TECHNICAL SERVICE BULLETIN

MT88 Manual Transmission - Rotational Scraping Noise When Cold And In Neutral, 1st And/Or 2nd Gear With Clutch Pedal Released

23-2019
08 June 2023

Ford 2021-2023 Bronco	Transmission/Transaxle: MT88
---------------------------------	------------------------------

Figure 1

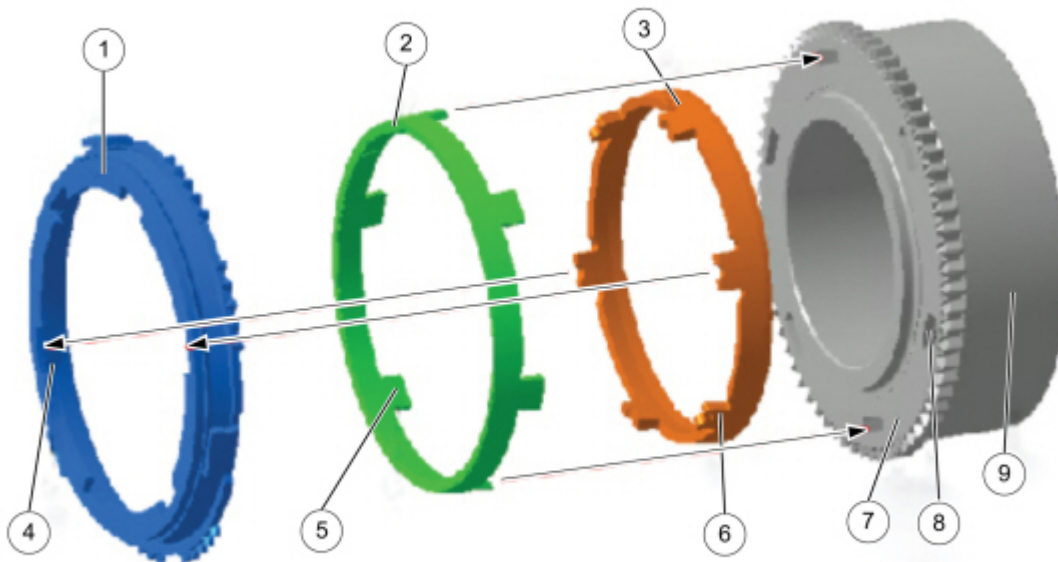
1. Remove the transmission from the vehicle, Refer to Workshop Manual (WSM), Section 308-03.
2. Disassemble the sub-assemblies to gain access to the 5th and 6th gear synchronizer rings. Refer to WSM, Section 308-03.
3. Replace the 5th and 6th gear synchronizer rings.
4. Assemble the transmission. Refer to WSM, Section 308-03.
 - (1). The reverse/crawl gear synchronizer assembly must be assembled on the transmission. Refer to Figures 1-2 for an exploded view of the reverse/crawl gear synchronizer assembly.

NOTE: New 5th and 6th gear synchronizer rings are now available with an improved design to correct the rotational scraping noise. Upon receiving the synchronizer rings, check for engineering part number MU7R-7101-GA or later which will be stamped on the rings.
